# TECHNICAL ALERT

TA00 1202

## Inlet Valley End Clamps ERR7282

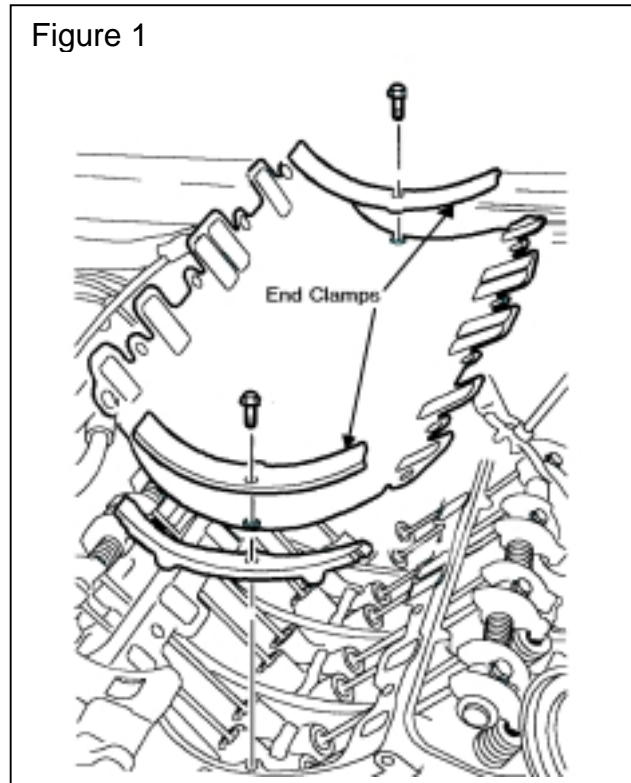
These clamps are **reusable** components (Figure 1). The two clamps should be reused when performing inlet gasket installations on vehicles **after** the safe VINs listed below:

**NOTE: Any unusual circumstances requiring the replacement of end clamps (ERR7282) after the safe VINs should be reported on an electronic Product Report.**

Vehicles manufactured **before** the above VINs should have a complete set of valley gasket components and bolts installed when a repair is performed
